Town of Hilton Head Island
Design Review Board Meeting
Tuesday, January 12, 2021 – 1:15 p.m.
AGENDA

Town of Hilton Head Island
Design Review Board Meeting
December 8, 2020 at 1:15 p.m. Virtual Meeting
MEETING MINUTES

**THE TOWN OF HILTON HEAD ISLAND
DESIGN REVIEW BOARD – NOTICE OF ACTION**

DESIGN TEAM/DRB COMMENT SHEET

SITE PLAN
PROPOSED RESTAURANT
#8 OFFICE WAY - HILTON HEAD ISLAND, SC
Prepared For
DIVERSIFIED DESIGNS, P.C.

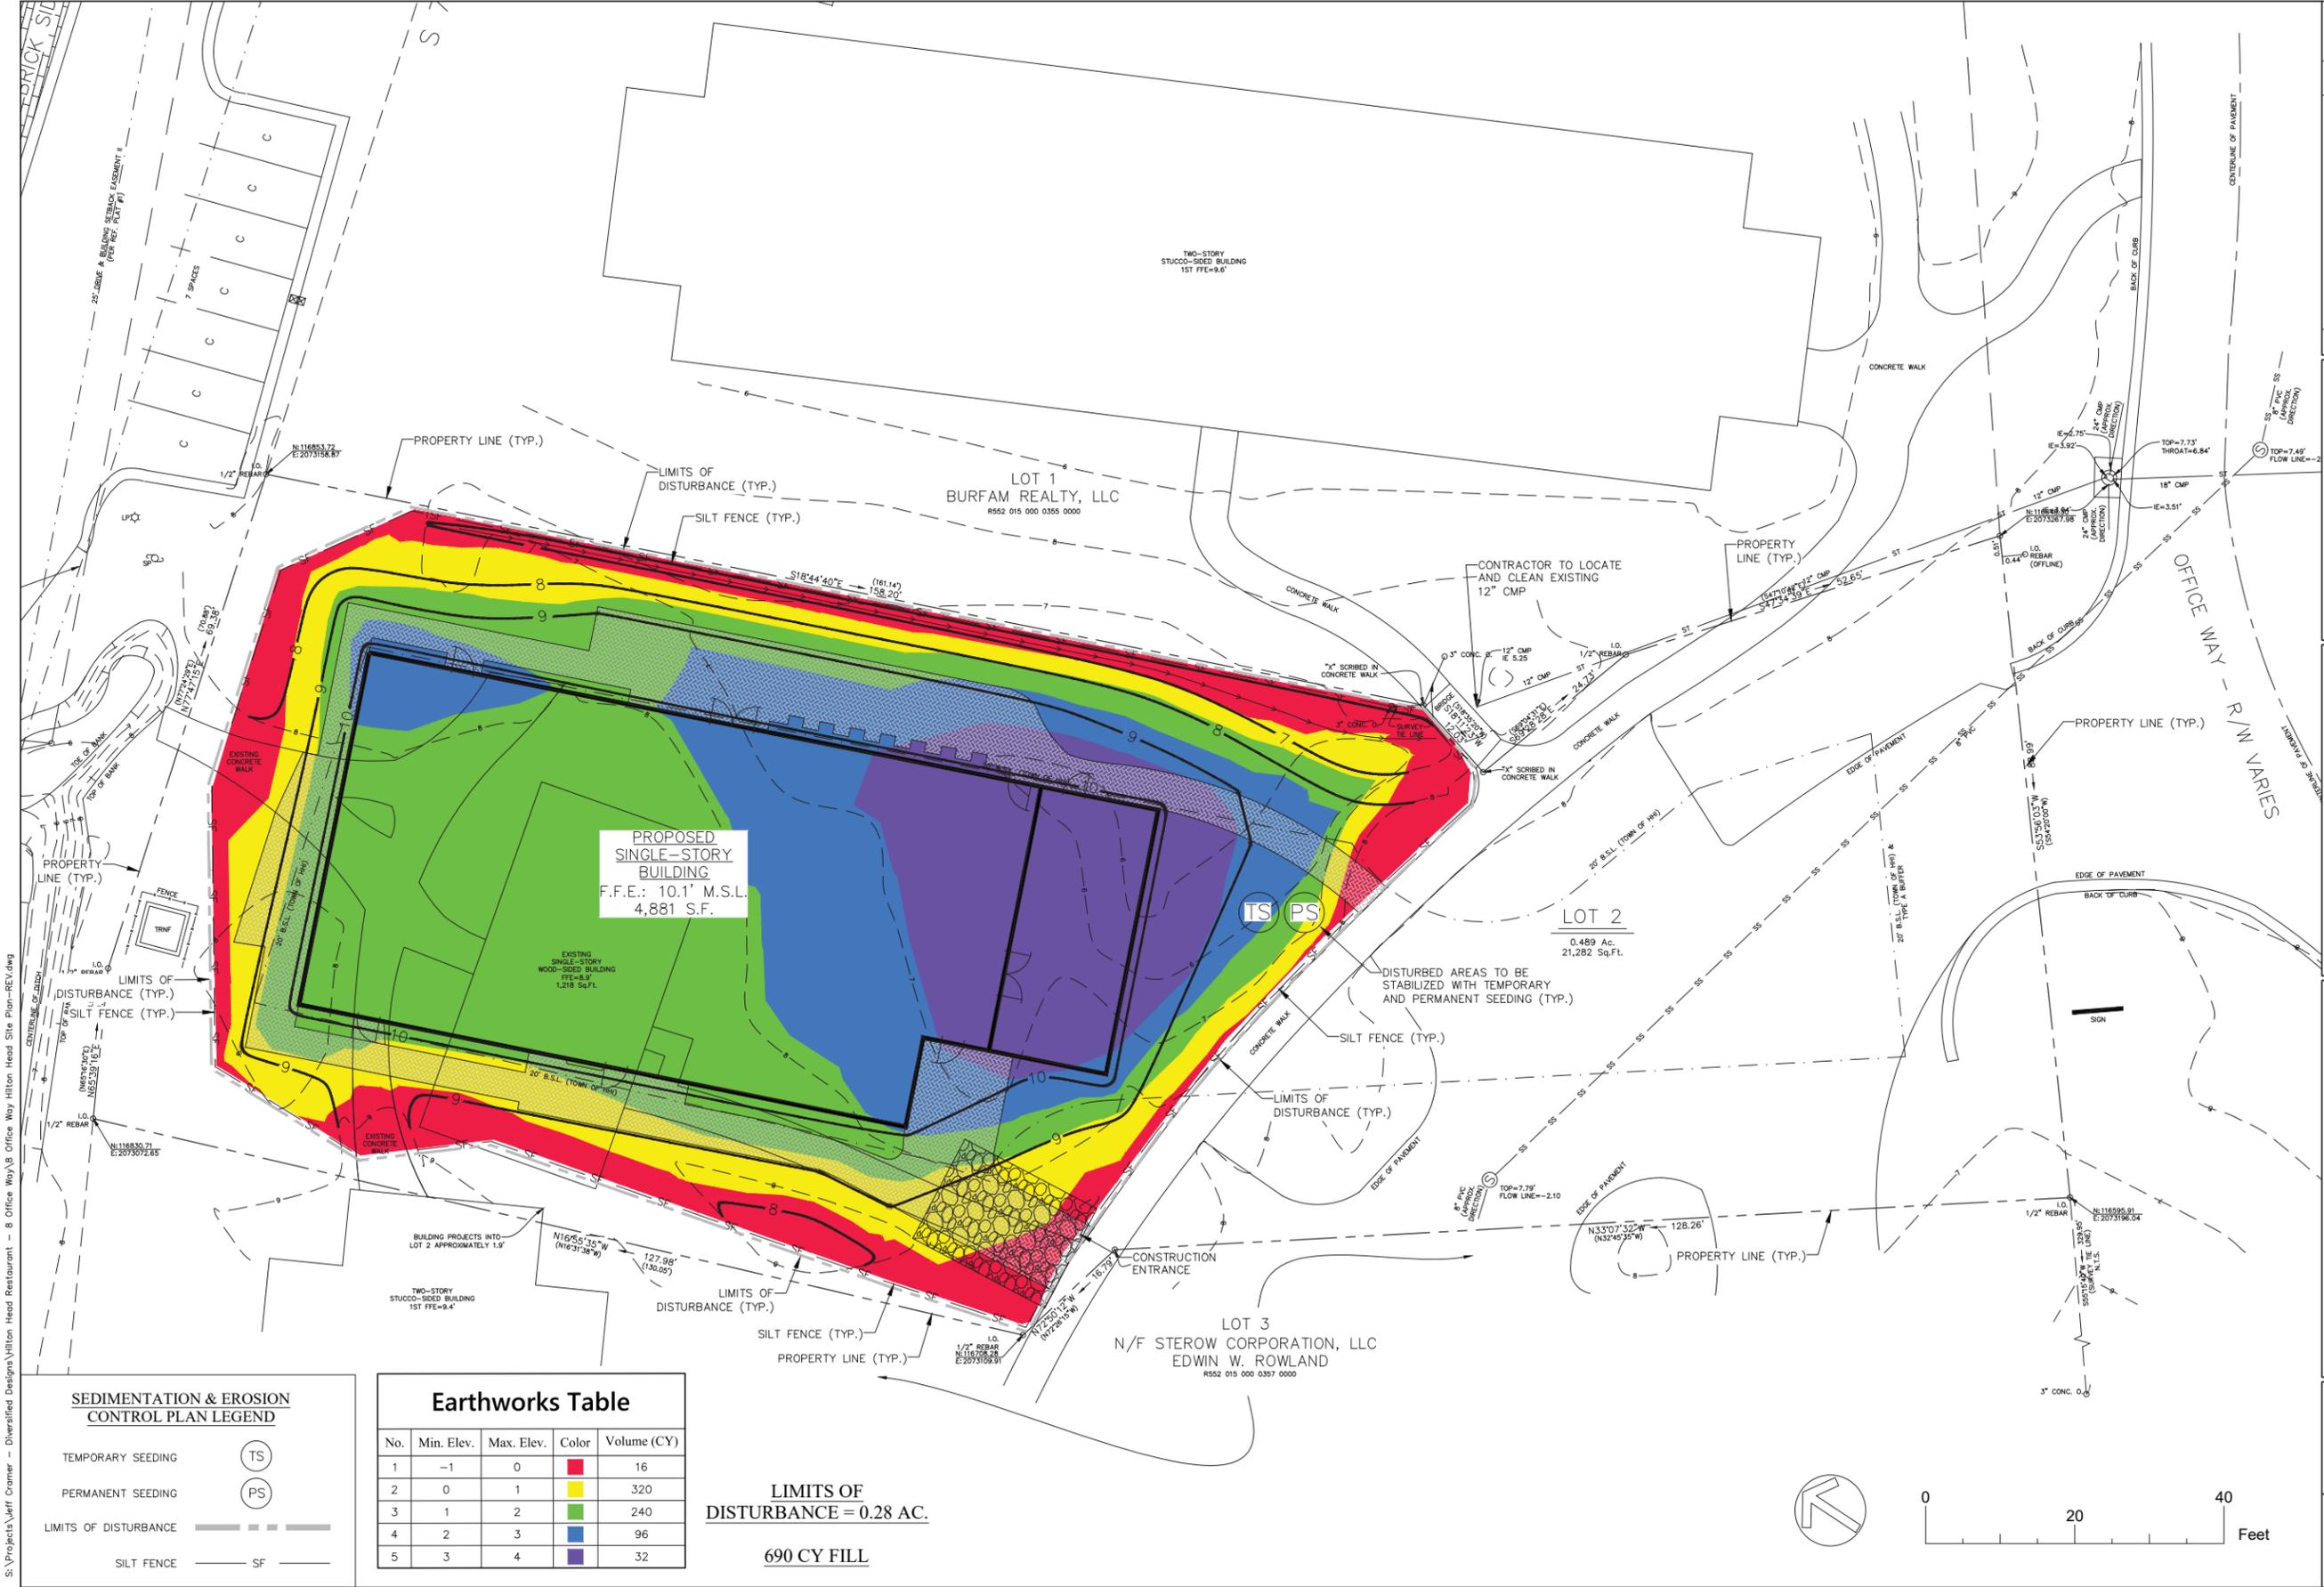
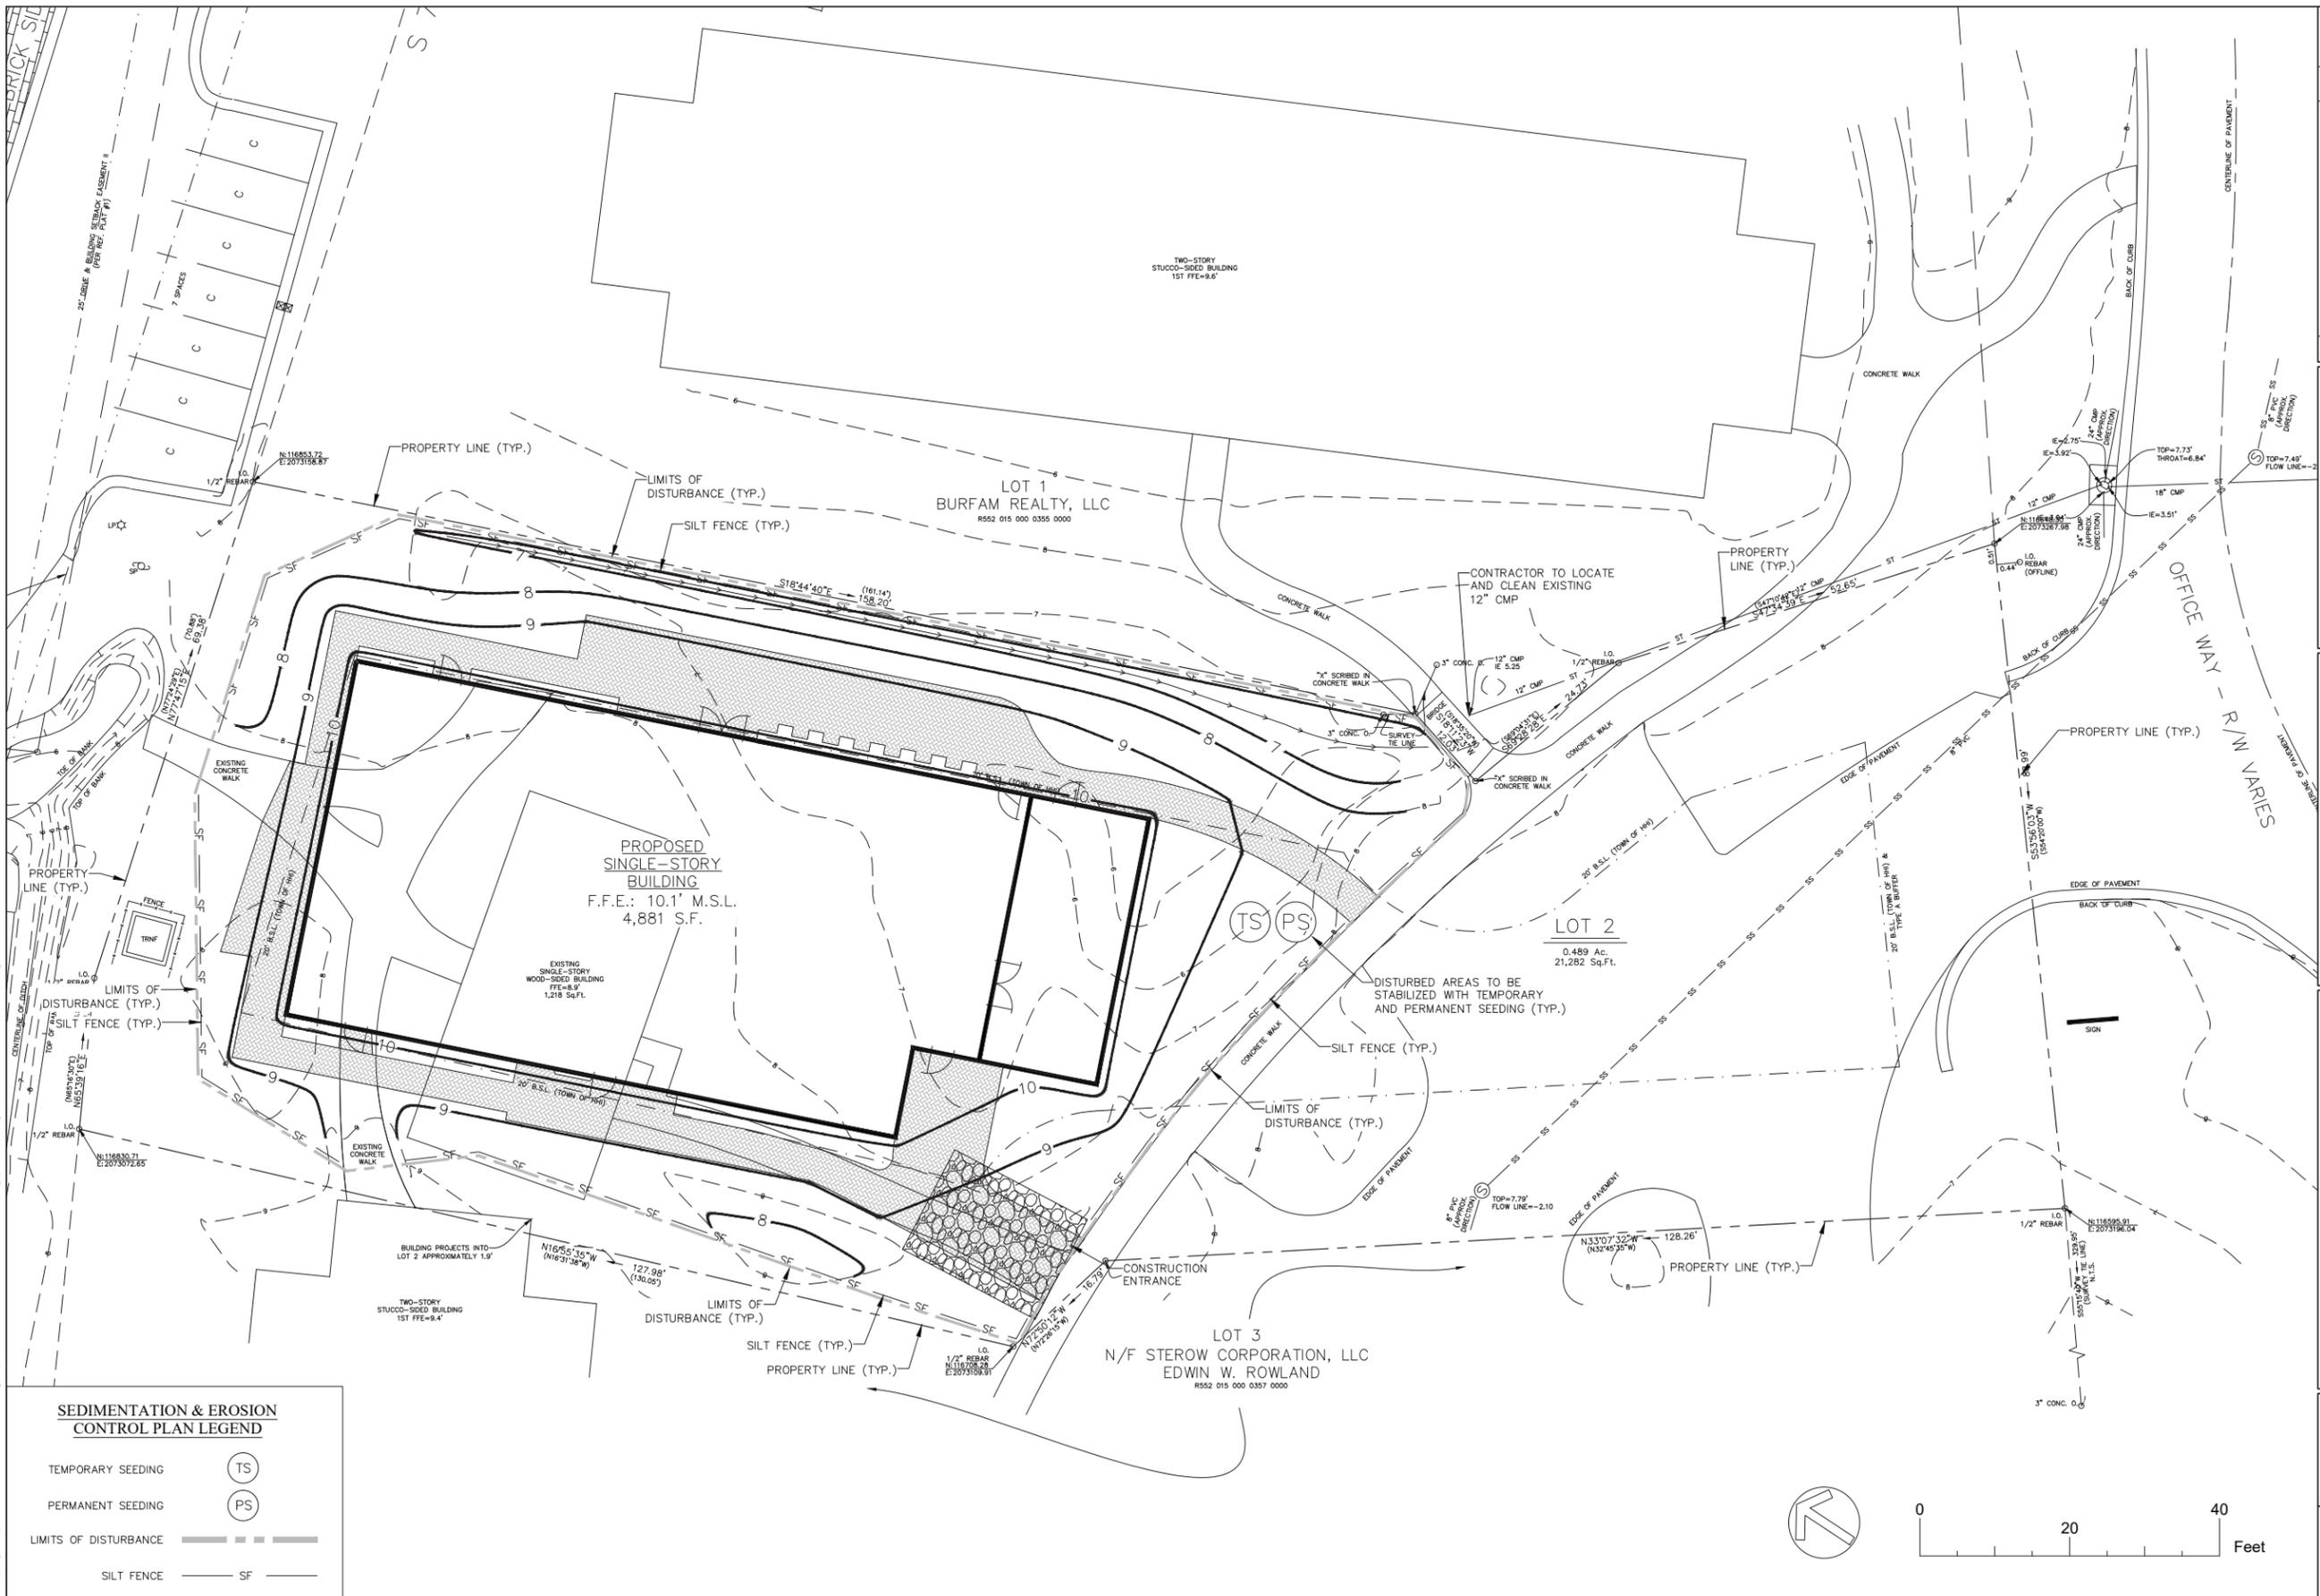
3. Finished floor elevation noted as 10.1', with existing grades ranging from 6' to 8' around the building. Building elevations are drawn as if slab on grade, which can't be possible with 2' difference between grade and floor. Either fill will be placed or there will be steps/ramps. No final grading plan provided showing what final grades will be and/or how entry to building will be achieved. ***Engineer is fixing.***
